**MT-9042A DUAL COUPLER MOUNT ASSEMBLY
ROCKWELL COLLINS PART NUMBER (RCPN) 622-8124-001**

SERVICE BULLETIN MT-9042A-23-1

**COMMUNICATIONS - MT-9042A - TUNE FAULT MITIGATION REGARDING
HIGH ANTENNA LOOP RESISTANCE**

Measure Resistance
Figure 1

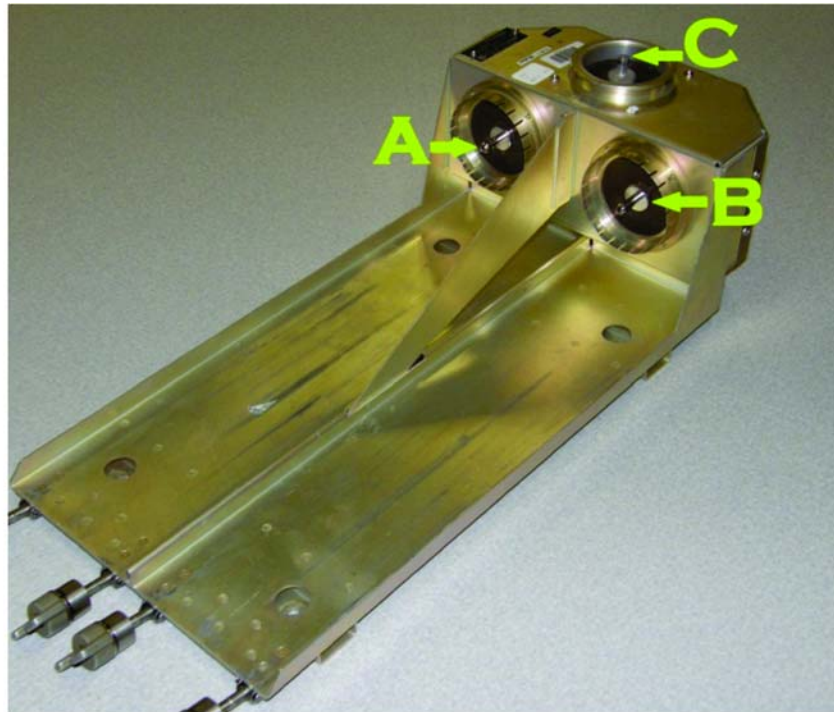
- (1) Pretest the dual coupler mount prior to modification. Testing where applicable can take place on the airborne platform.
 - (a) Use a milliohmeter to measure the resistance from center pin A to antenna center pin C and from center pin B to antenna center pin C. Refer to Figure 1, points A, B and C. This measurement should be less than 1 milliohm. If measurement is greater than 1 milliohm then installation of this service bulletin is recommended.

- (1) Using a milliohmeter measure the resistance from coupler mating center pin A to antenna center pin C and from coupler mating center pin B to antenna center pin C. Refer to Figure 1, points A, B and C. This measurement should now be less than 1 milliohm.
- (2) Using a milliohmeter measure the resistance from ground ring D to chassis E and from ground ring F to chassis E. Refer to Figure 2, points D, E and F. This measurement should now be less than 1 milliohm.

Measure Resistance From Ground
Figure 2

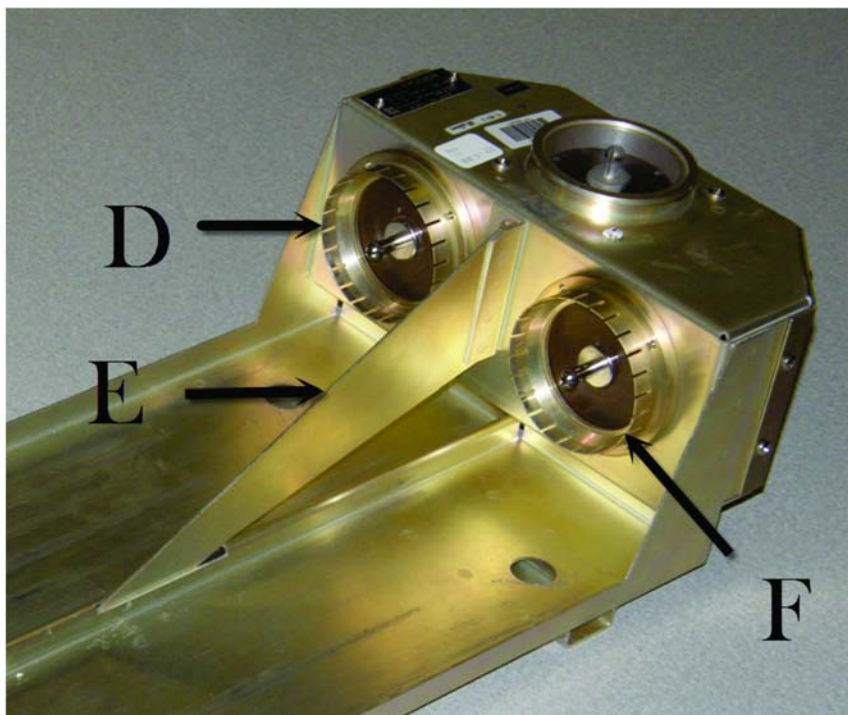
- (b) Use a milliohmeter to measure the resistance from ground ring D to chassis E and from ground ring F to chassis E. Refer to Figure 2, points D, E and F. This measurement should be less than 1 milliohm. If measurement is greater than 1 milliohm then installation of this service bulletin is recommended.

Cover Screws
Figure 3

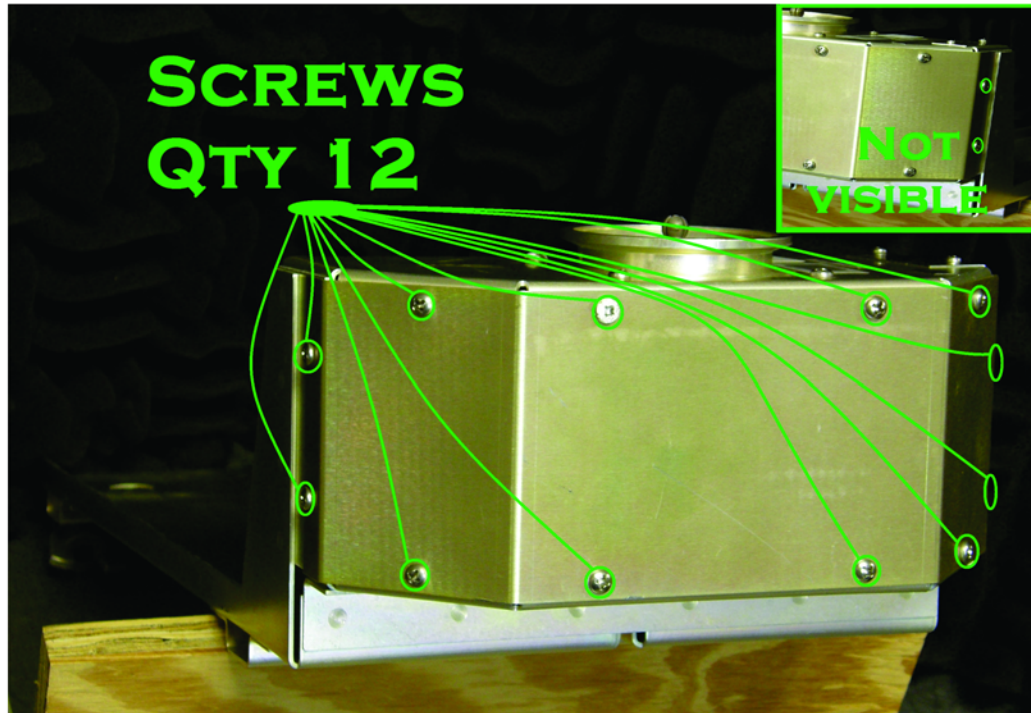
(a) Remove 12 cover screws. Refer to Figure 3.

- (f) Reinstall cover using 12 screws, hand tighten or torque to 12 +/- 1.1 inch pounds. Refer to Figure 3.

Coupler Ground Ring Screws
Figure 4

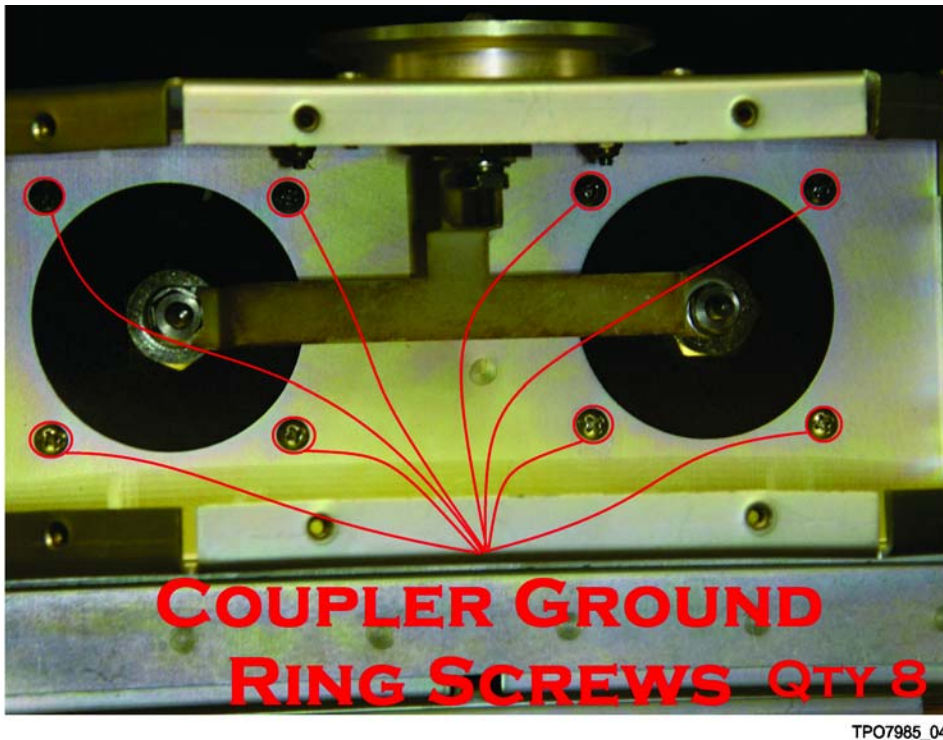
- (b) Locate and remove contact rings by removing four (4) screws for each ring. Refer to Figure 4, remove and discard lock washers.

- (c) Reinstall ground rings ensuring ground rings bottom out on mount chassis and torque four (4) screws each ring to 12 +/- 1.1 inch pounds. Refer to Figure 4.
- (d) Repeat Step 3.A.(2)(b) and Step 3.A.(2)(c) for both ground rings D and F. Refer to Figure 2, D and F.

Nut Locations
Figure 5

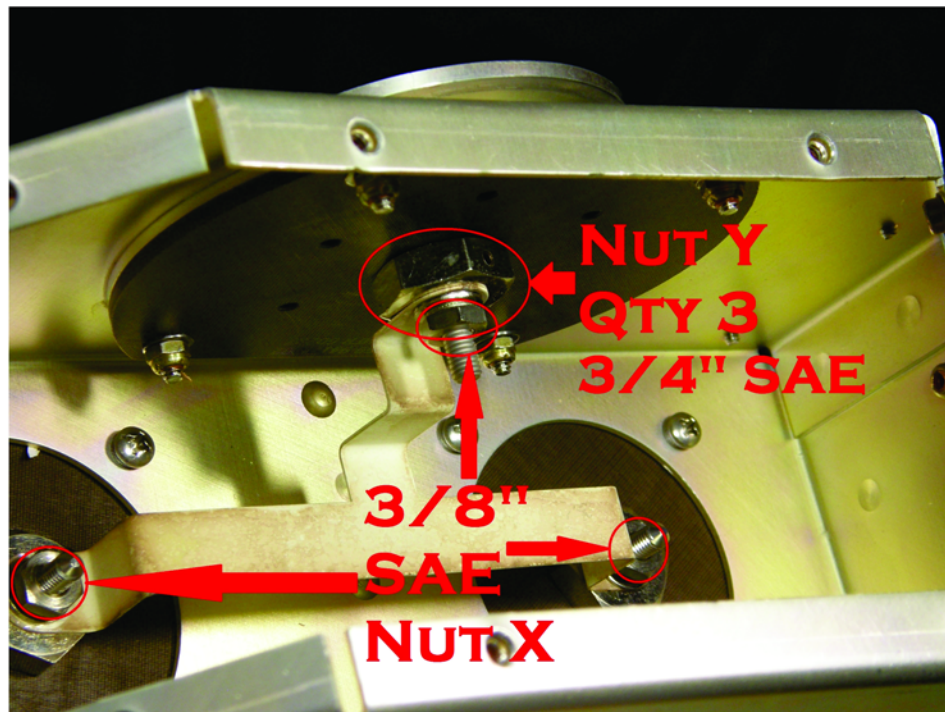
- (e) Ensure electrical contact points A, B and C are restrained from turning using 5/8 SAE wrench or similar tool when torquing. Refer to Figure 5 and Figure 6. Protect brown insulator from damage, such as scrapes and gouges during torquing of points A, B and C. Refer to Figure 5 and Figure 6. Torque three (3), 3/8 SAE nuts for the electrical contact to 26 +/- 2 inch pounds. Refer to Figure 5 and Figure 6.

Post Locations
Figure 6

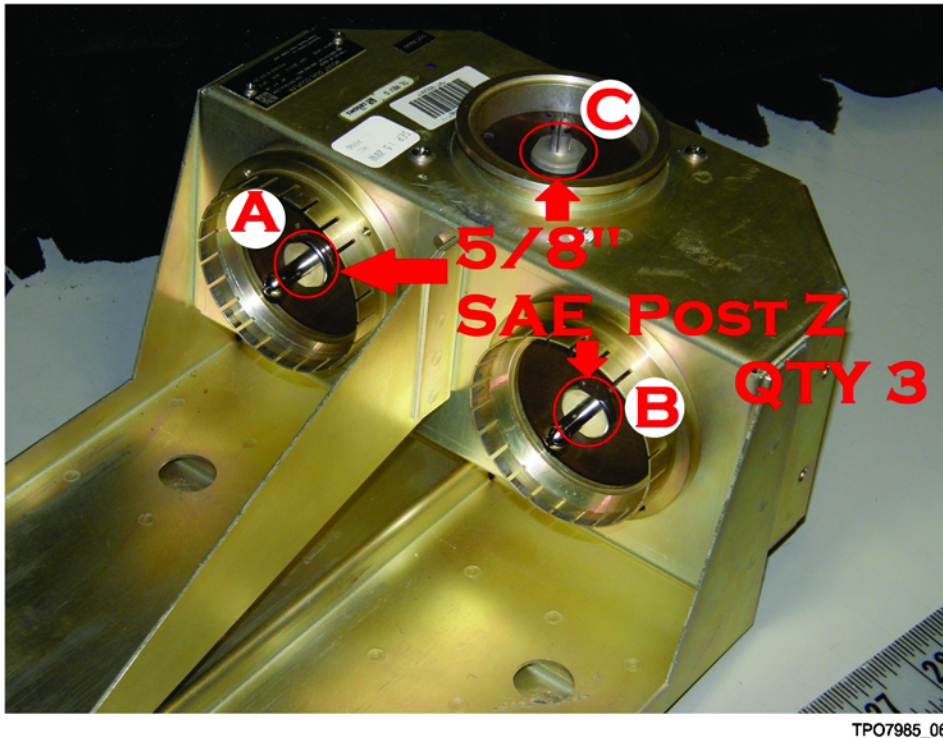
NOTE: To help protect brown insulator from tool damage, tape on the end of the tool works well.
